**RESPONSIVENESS SUMMARY
TO THE PEER REVIEW
OF THE MODELING FRAMEWORK DESIGN
AND QUALITY ASSURANCE PROJECT PLAN**

**Modeling Study of PCB Contamination
in the Housatonic River**

DCN: GE-053102-AB AQ

**Environmental Remediation Contract
General Electric (GE)/Housatonic River Project
Pittsfield, Massachusetts**

Table 4.5 Observed and Simulated Daily Flow for the Quinnipiac River at Wallingford - Calibration and Verification (Top curves are Daily Precipitation)

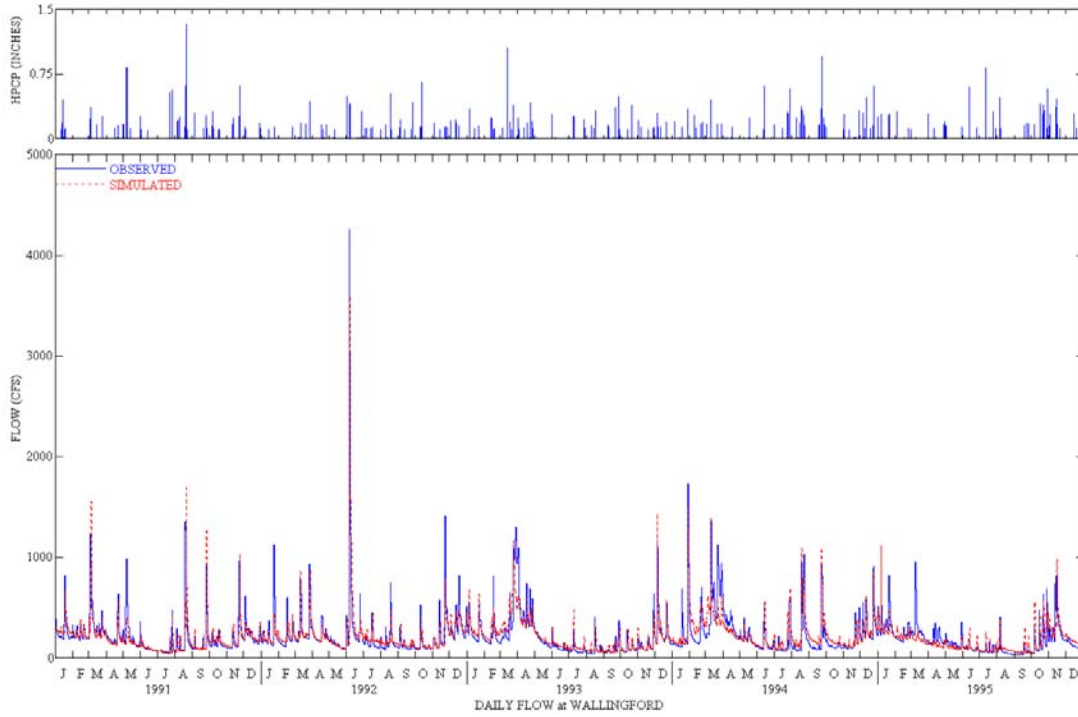
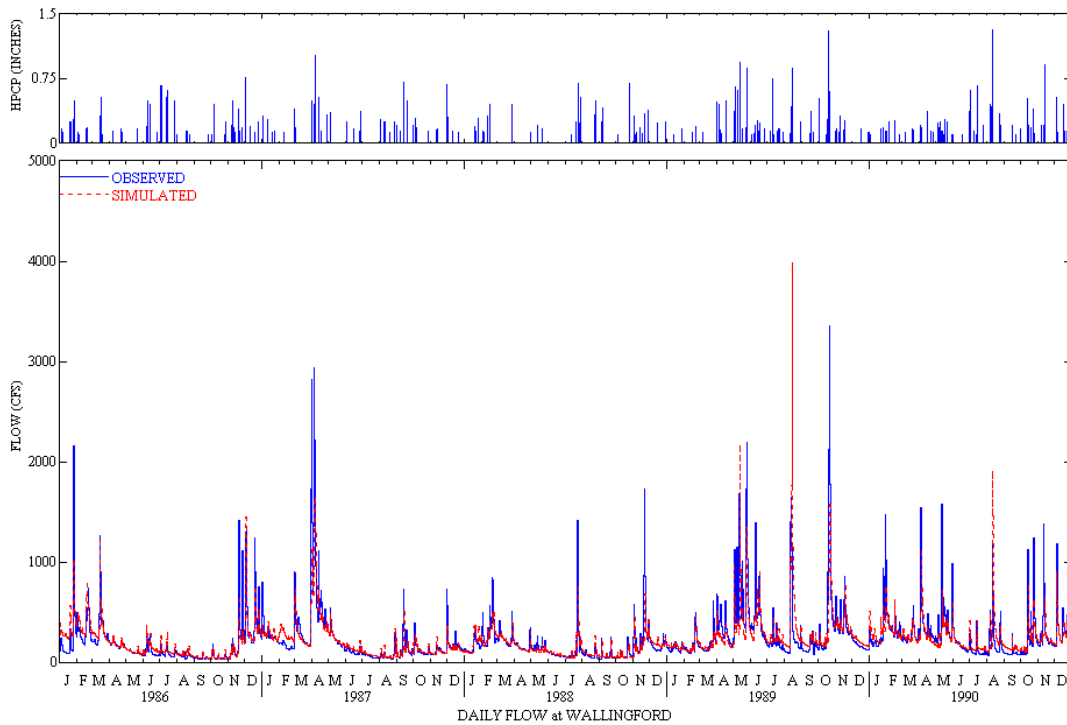
7. Pg. B-5 Recent HSPF Applications – Where are testimonials to its effectiveness and examples of its ability to predict hydrologic outcomes? (JL1-21)

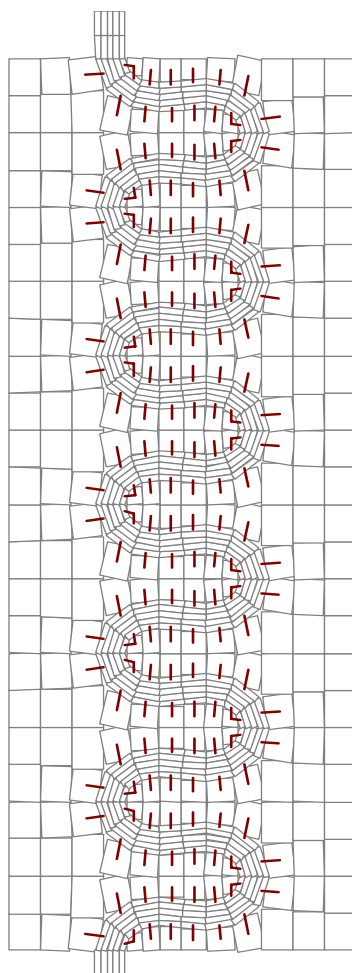
52. Pg. 4-42 – Gridding has not been used previously in such a flow configuration? Why do not the answers to these questions already exist? Has the model been used in this type of situation before? If so where can the documentation be found? (JL1-10)

54. Pg. C.1-3, line 41. Grid strategies for EFDC are still being tested? Has it not previously been applied in such a flow situation before? If so, where is the documentation? (JL1-22)

118. (p.4-47) Similarly, I am concerned about the issues of dual gridding, grid matching, etc. This sounds like interesting research that might not bear fruit in a timely fashion? Again, could a simpler model be chosen? (EA16)

Response: This is the first application of the EFDC to a highly meandering river system with a large expanse of associated floodplain. Due to the complexity of this study, a rigorous development and testing phase of both the EFDC code and its application to the Housatonic River is proposed for this modeling study. During the early phases of the MFD development, a wide range of options were considered. The primary focus of the grid development effort proposed in the MFD is on the use of a curvilinear grid for primary channel/proximal floodplain (called the “main channel”) and a separate linked grid which represents the distal floodplain (see the following Figure, where the inner three cells represent the river channel, the outer two cells represent the proximal floodplain, connected to the distal floodplain cells). The significance of proximal versus distal floodplain is two-fold. First the proximal floodplain will be routinely (approximately every 2-5 years) inundated and in the “floodway”. During these frequent storms, this area will experience relatively high shear stresses and will need to dynamically interact with the main channel. Momentum transfer between the proximal and channel cells will be important. Secondly, the proximal floodplain contains a significant portion of the PCB mass that needs to be addressed to achieve the modeling study objectives.

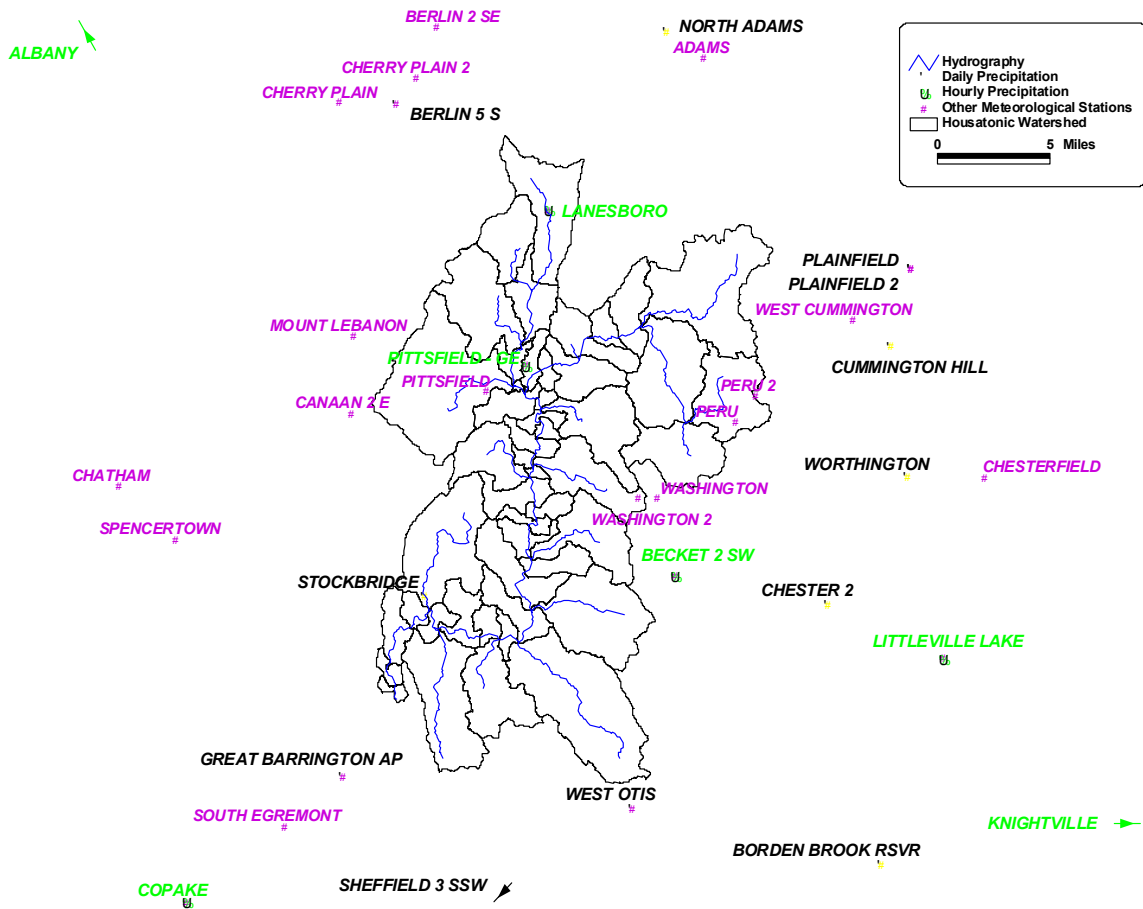
55. On page 4-12, it is indicated that daily rainfall data will be disaggregated into hourly records. Please discuss the procedure to be followed in more detail. Will spatial and temporal patterns be linked so as to properly represent passing storm fronts? (PS10)

115. (p. 4-12) To properly simulate run-off from local storms requires data well resolved in space and time. I would like to see more discussion of the method of extrapolating/interpolating precipitation data from one site to another and the disaggregation of data from longer to shorter time steps. (EA13)

Response: The procedures to be used to disaggregate the daily values to hourly involve using a nearby hourly record to provide the distribution for the daily gage value. For each day, the 24 hourly values are analyzed to calculate the fraction of the daily total that occurred in each hour; these 24 fractions, which sum to 1.0, are then used to distribute the total for the daily gage into 24 hourly values. These procedures have been used on a number of applications over the past decade; they were originally implemented in a USGS program called METCMP, and have recently been incorporated into the WDMUtil program supporting BASINS users (see www.epa.gov/ostwater/BASINS/support.htm). Special coding is implemented to accommodate periods of missing and/or accumulated data, and messages are provided to the model user when manual fill-in of data may be required. In addition, users can identify multiple hourly stations and the code will select the hourly station that has a daily total that most closely matches the total for the daily gage being distributed.

For the Housatonic River watershed, hourly precipitation data are available at Lanesborough, MA (through 1995) and the GE Pittsfield facility (1994 – present), along with a number of stations (with shorter records) surrounding the watershed at Becket 2 SW (MA), Littleville Lake (MA), and Copake (NY), and long-term stations at Albany and Hartford. The meteorological stations and their periods of record were listed in Table F-8 of the MFD; unfortunately, that table was incomplete in the published MFD, so a complete Table F-8 is attached as Appendix J.

Yellow Perch - Whole Body vs. Fillet PCB Concentrations (r = .57)

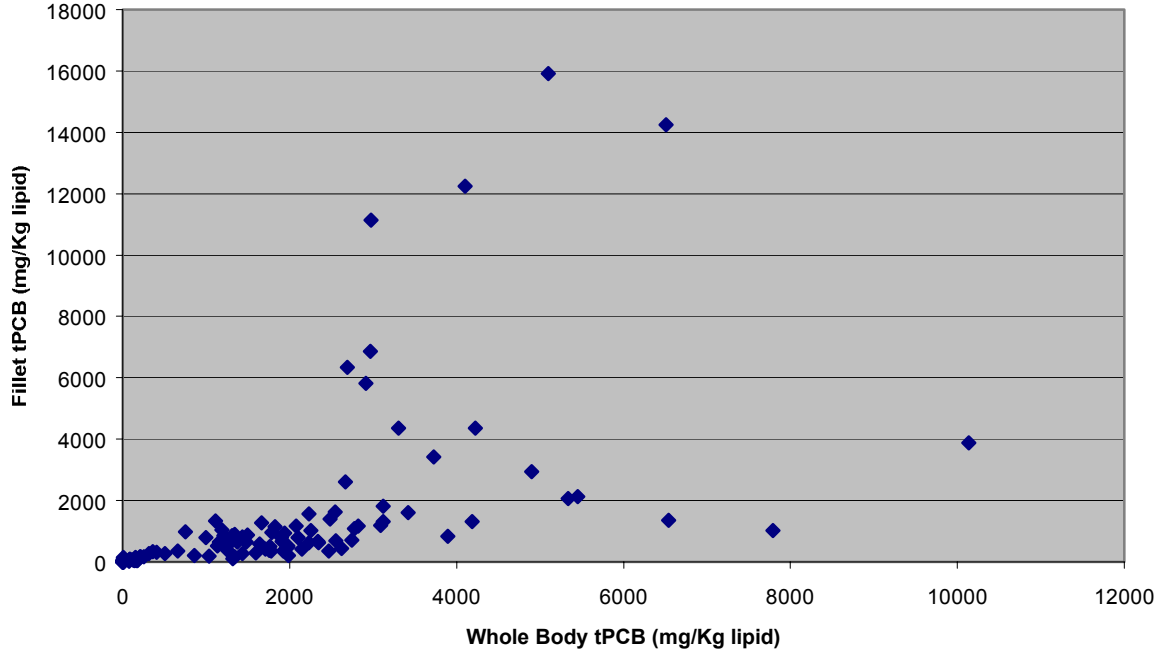
62. Relating PCB concentrations in whole fish vs. filets: Bioaccumulation models predict whole organism chemical concentration; human health-based risk assessment requires chemical concentration in the edible portion/filet. How will the former be converted into the latter? If a relationship based on data is planned, please provide a scatterplot to demonstrate the correlation. (DE16)

Response: The primary purpose of the model is not to support the human health risk assessment, which will precede the modeling of baseline conditions. However, the HHRA will inform the modeling team as to concentrations of concern as well as GE’s proposal of IMPGs. There are multiple ways of deriving chemical concentrations in the edible portions of tissues. First, there are site-specific data, which include extensive fillet and offal analyses. These data can be used to generate empirical relationships between whole-body and filet concentrations for a number of species; these may be extrapolated to samples for which only whole-body predictions have been made. Second, a theoretical partitioning approach can be employed, whereby lipid-partitioning theory (lipid-based normalization technique) is used to partition PCBs between fish offal and fillet. Final selection of a method will consider these and other approaches, and consider the
